# Technical Repercussion Sheet

| <b>TITLE:</b><br>E.a.E. - Cable Loom Install. drawings-Modify harnesses installation for OHSC in Door Zone D3 LH FWD (sol.E) | ATA: 9280                  |

The modification consists in modifying harnesses installation for OHSC in Door Zone D3 LH FWD (solution.E)

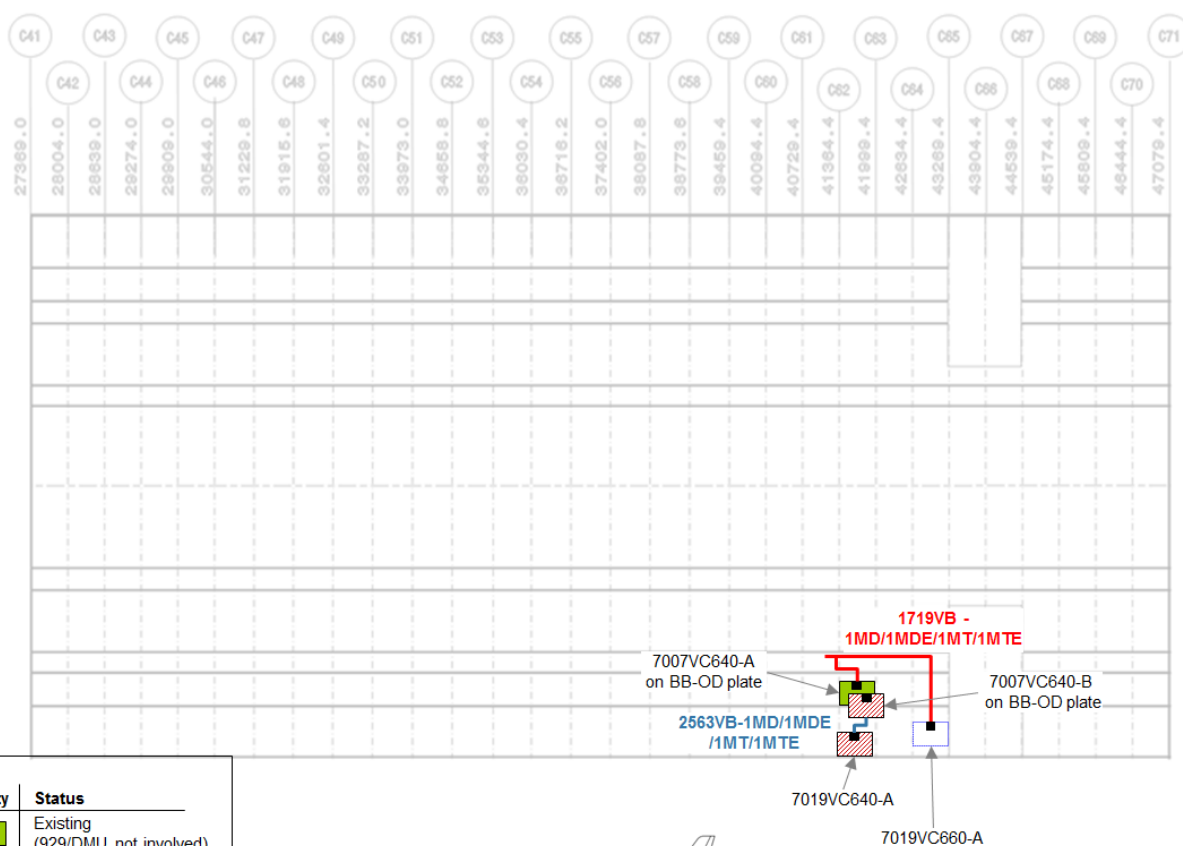
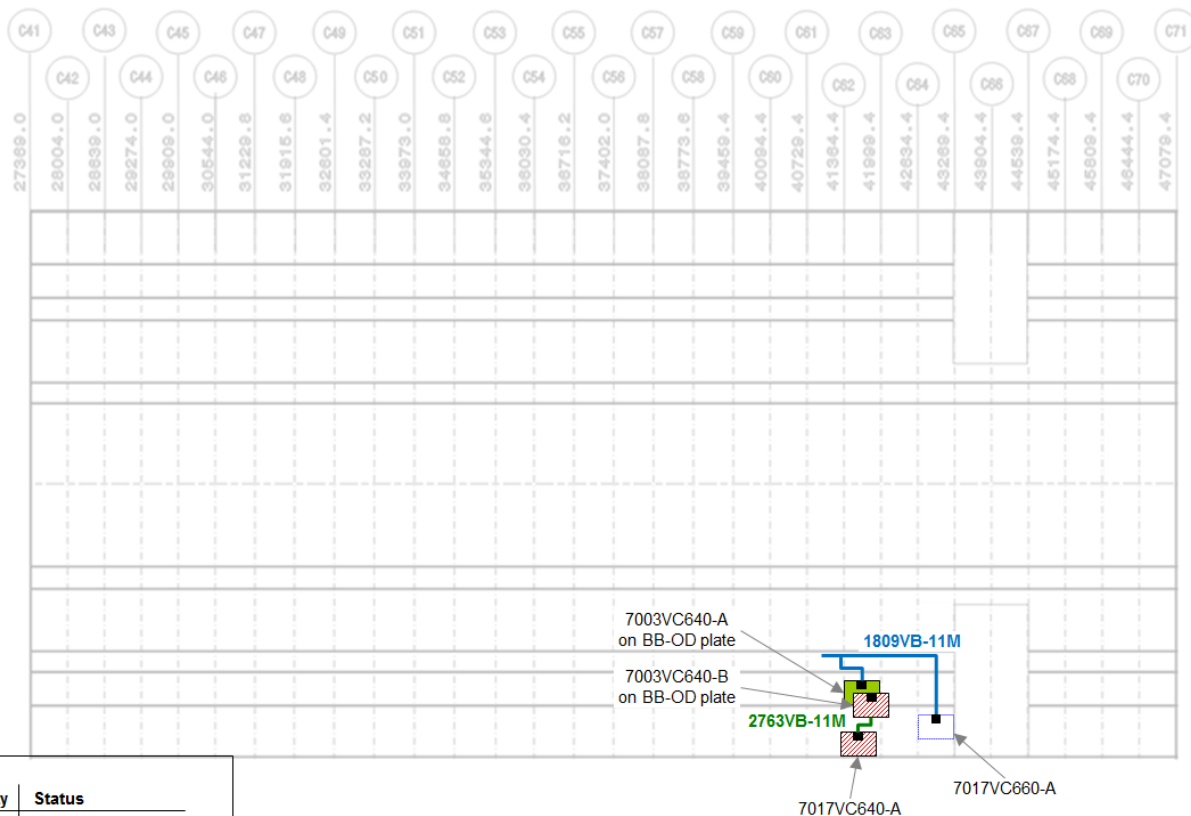
The modification consists in modifying harnesses installation for OHSC in Door Zone D3 LH FWD (sol.E).

Sketch CEF ESI HAR EQT 1

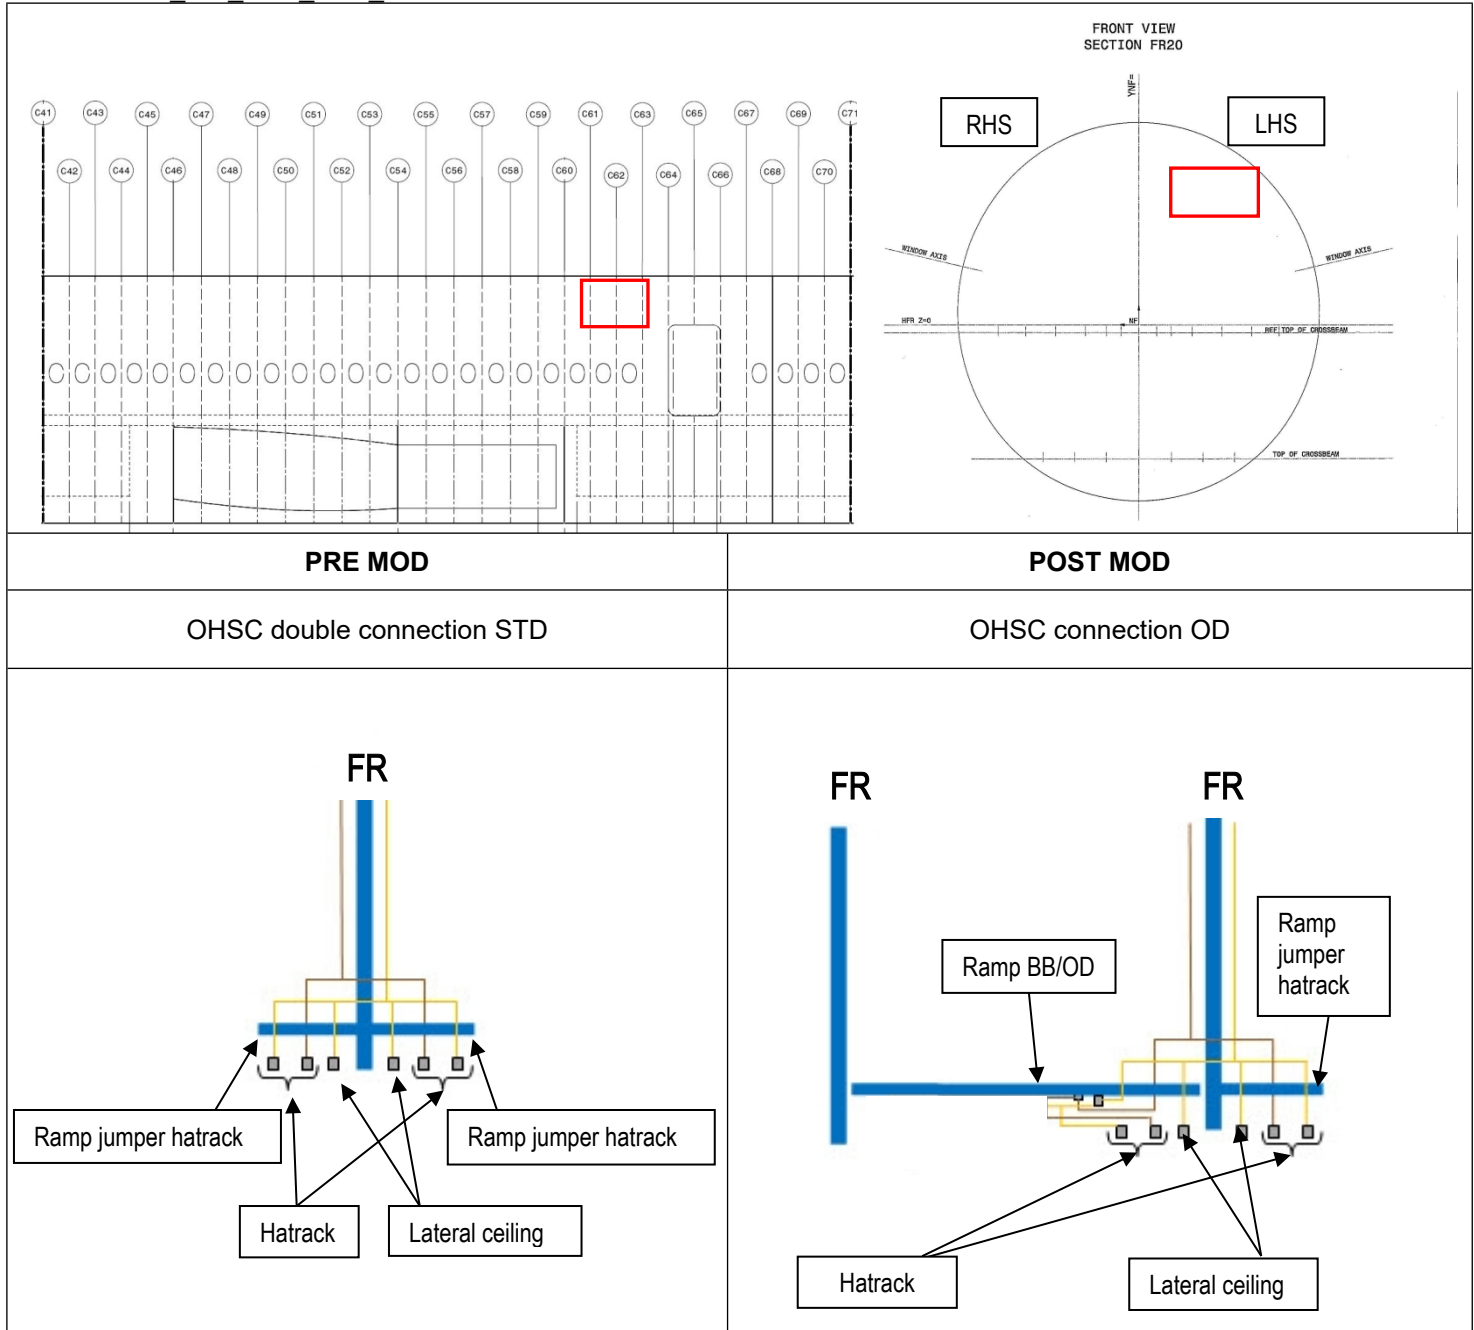
To modify 1 derivation by relocating 3 clamps and 3 spacers between FR62 and FR63.  
(see sketch 1)

To modify 1 derivation by relocating 3 clamps and 3 spacers between FR62 and FR63.  
(see sketch 1)

To add 1 derivation by adding 3 clamps and 3 spacers between FR62 and FR63.  
(see sketch 1)

To add 1 derivation by adding 3 clamps and 3 spacers between FR62 and FR63.  
(see sketch 1)

Sketch CEF\_ESI\_HAR\_EQT\_2

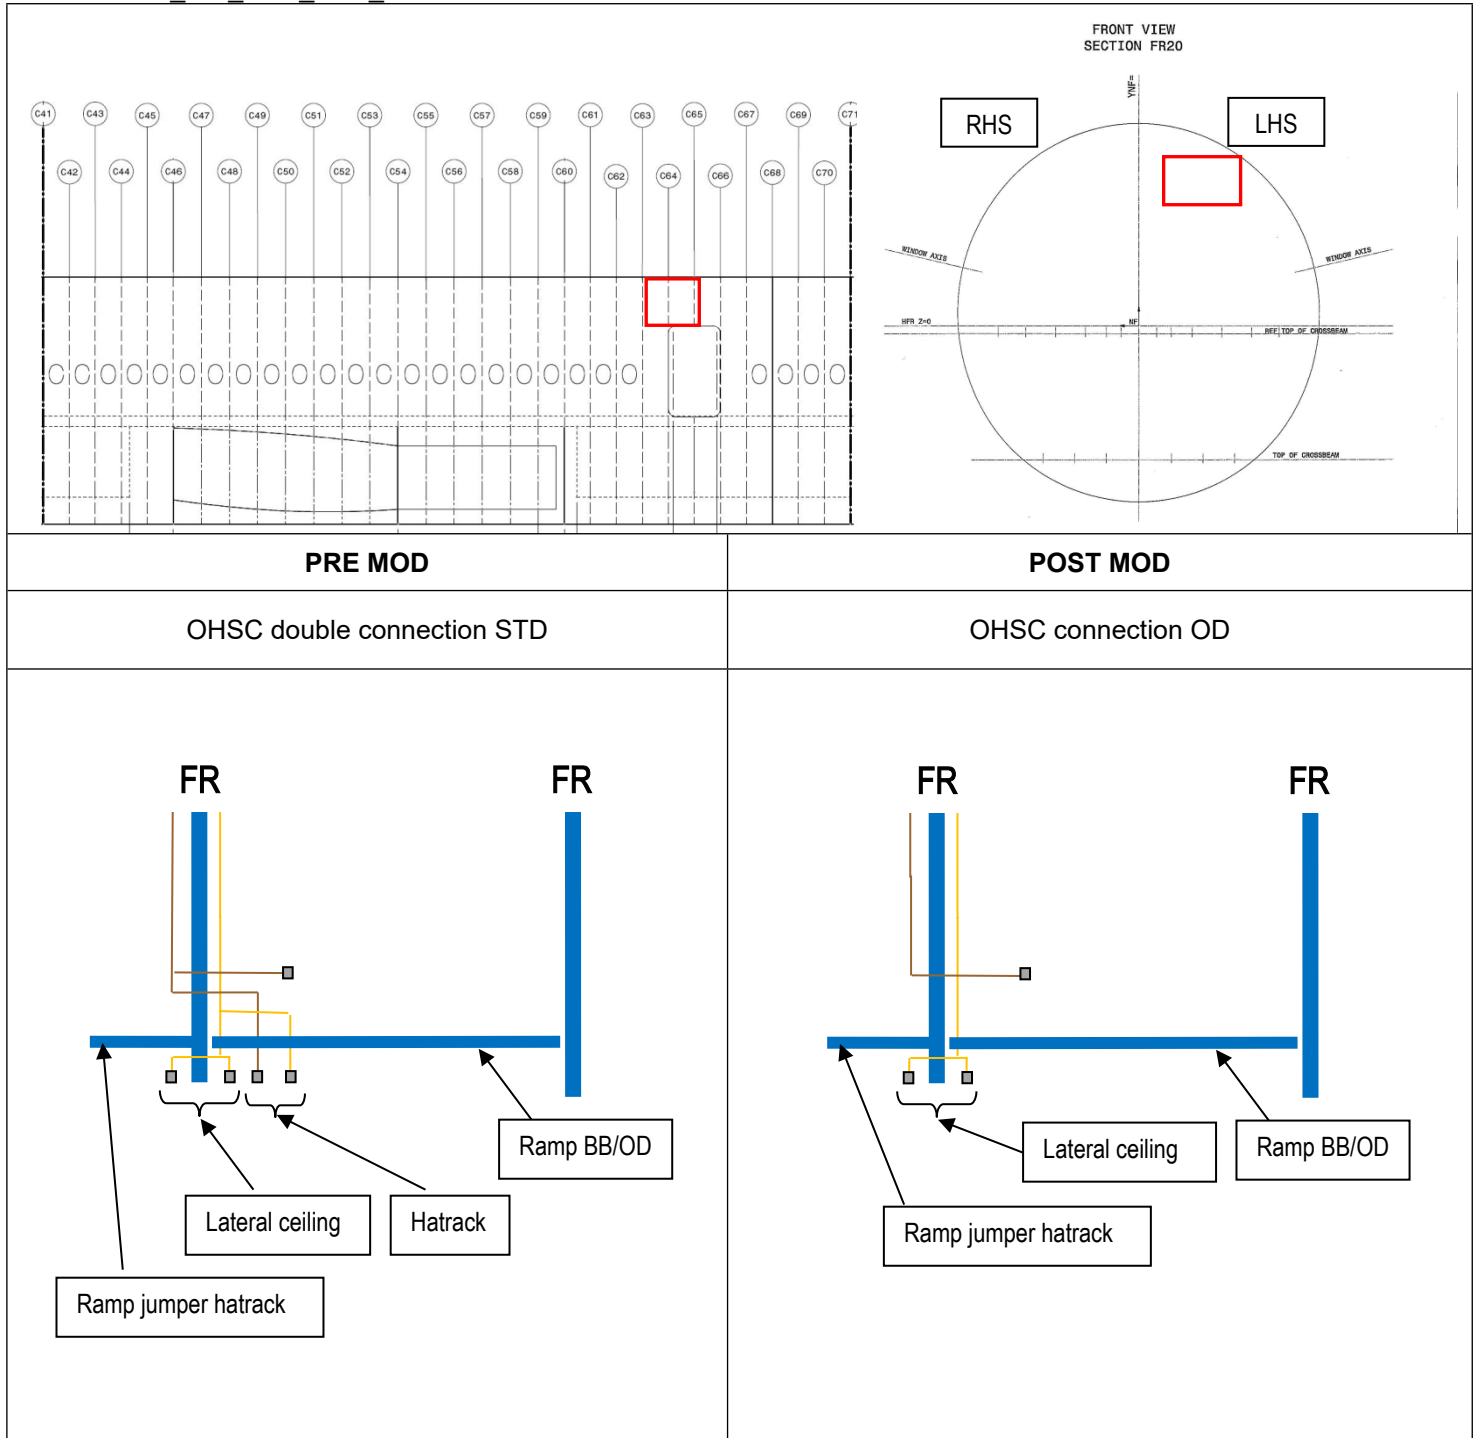
To remove 1 derivation by removing 2 clamps and 2 spacers between FR64 and FR65.  
(see sketch 2)

To remove 1 derivation by removing 2 clamps and 2 spacers between FR64 and FR65.  
(see sketch 2)
